Technical Service Bulletin

GROUP RECALL	NUMBER 21-01-010H
DATE February, 2021	MODEL(S) Tucson (TL)

SUBJECT: 2016-2021MY TUCSON (TL) ABS FUSE KIT INSTALLATION AND SOFTWARE UPDATE (RECALL CAMPAIGN 195)

This TSB supersedes TSB# 20-01-040H, expanding model year applicability and adding procedures / parts information for 2016-2018MY vehicles.

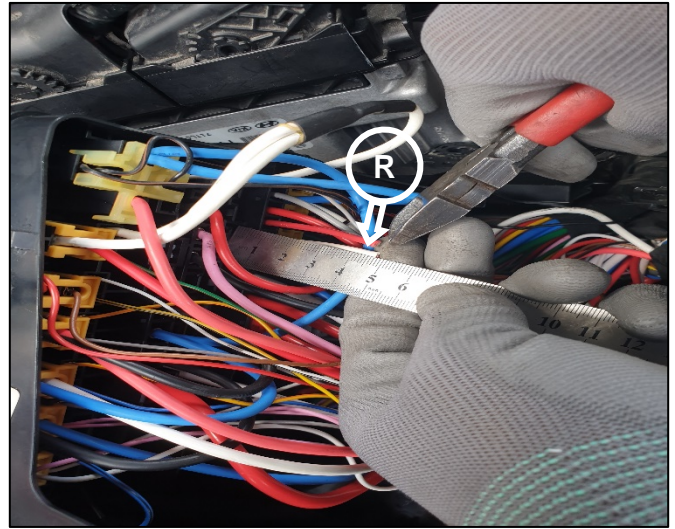
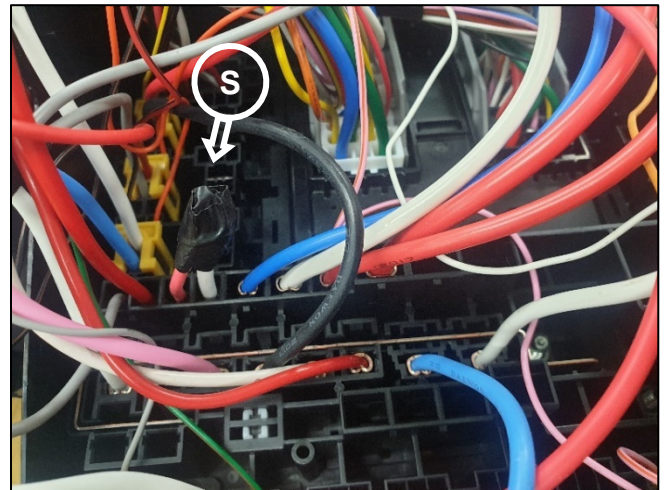
12. Cut the ABS1 and ABS2 fuse wires (red wire and white wire) approximately 50mm (~2") from the underside of the junction box (R).

13. Wrap the ends of the white wire and red wire attached to the multifuse with black electrical tape (S).

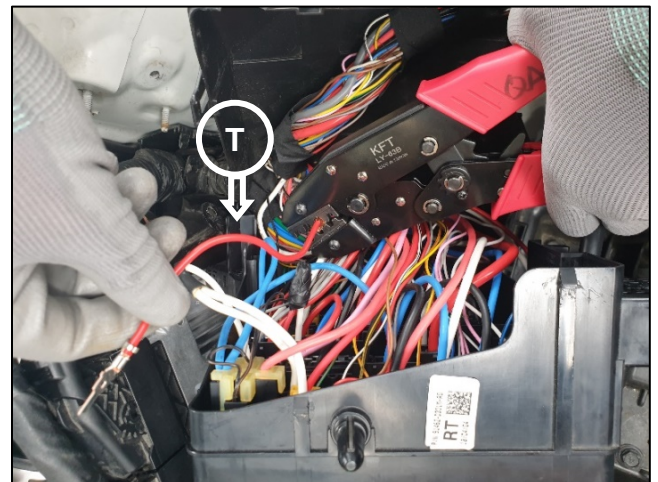
14. Connect the supplied lead wires (T) to the un-capped ends of the red wire and white wire using the supplied u-type crimp connectors and heat shrink tubing.

Slide the heat shrink tubing over the wire prior to crimping the lead wire.

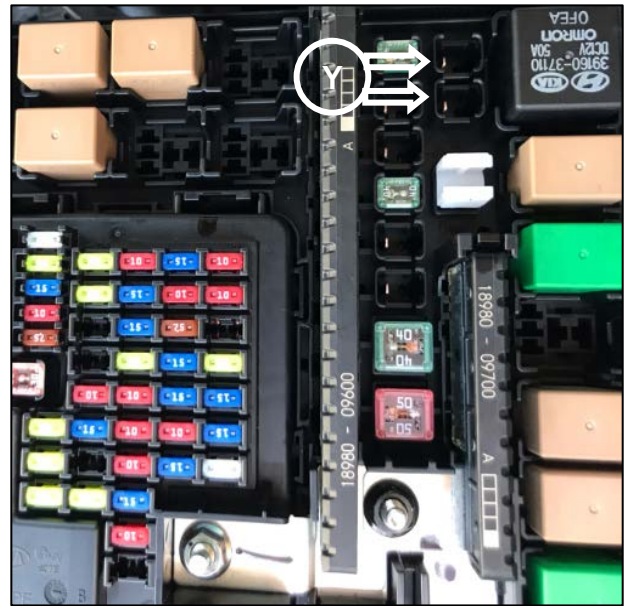
17. Install the supplied micro fuses in the new fuse locations (Y).

HECU part number 58920-D3530 requires 25A micro fuses

HECU part number 58920-D3550 requires 25A micro fuses

HECU part number 58920-D3100 requires 30A micro fuses
